RE: RESPONSE TO TRANSPORT FOR NSW INFORMATION REQUEST REGARDING 741 CUDGEN ROAD, CUDGEN

PSA Consulting has been engaged by Planit Consulting to provide traffic engineering advice for the proposed Cudgen Connection Health Precinct, located on land at 741 Cudgen Road, Cudgen (formally described as Lot 6 DP727425). The site is located within the Tweed Shire Council (TSC) Local Government Area.

A Traffic Impact Assessment (TIA) was prepared by PSA on 19 December 2024. This technical note outlines the response to comments and information request raised by NSW Government. The documents reviews include the following:

Figure 1: Proposed Tweed Coast Road / Cudgen Road Intersection and Site Access Intersection Layouts (Source: SIDRA)

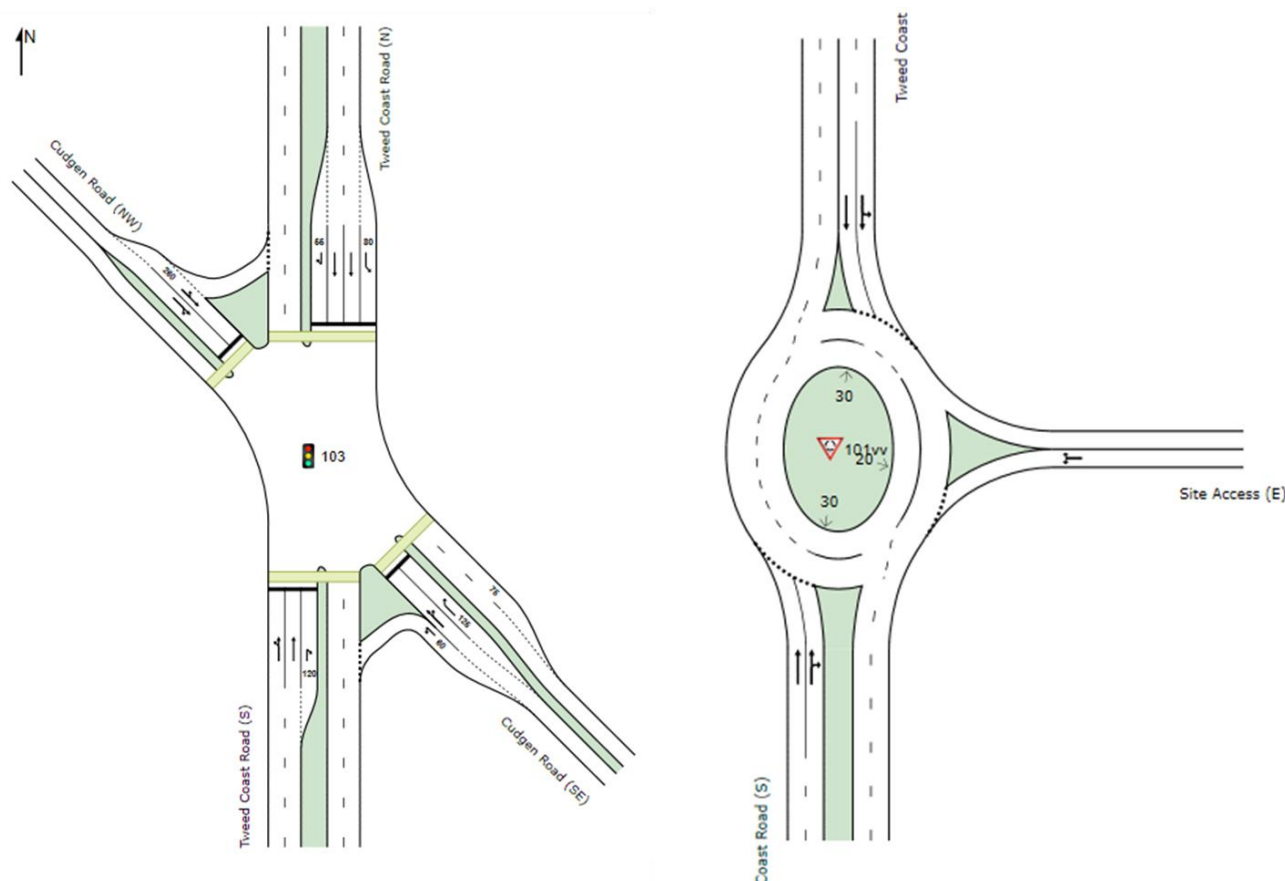
- *The roundabout proposed on Tweed Coast Road appears to be within 130 metres of the existing signalised intersection of Tweed Coast Road/ Cudgen Road. It is unclear what impact this arrangement will on the safety and efficiency of the Traffic Control Signals (TCS).*
- *The option for a roundabout will need to be further justified and demonstrated by updated modelling and the preparation of a strategic design. Alternatively, further options should be investigated to identify the appropriate infrastructure required to support the planning proposal.*
- *It is noted that the cycle time adopted for the TCS is incorrect, whereby the site runs 120 seconds in peaks. The revised modelling should ensure the correct value is adopted.*

Following feedback from Transport for NSW, the SIDRA model has been updated to incorporate the following modifications:

- The left-turn pocket on the northbound approach of the Tweed Coast Road / Cudgen Road intersection has been reduced to 80 metres to avoid creating a three-lane exit configuration at the roundabout.
- The signal cycle time at the Tweed Coast Road / Cudgen Road intersection has been adjusted to 120s, replacing the previously used SIDRA-calculated practical cycle time.

- All analyses assume that no connection with Tweed Valley Hospital has been established.

The Tweed Coast Road / Cudgen Road intersection has been assessed both in isolation and as part of the broader network, including the proposed roundabout access. The proposed intersection layout is illustrated in Figure 1.
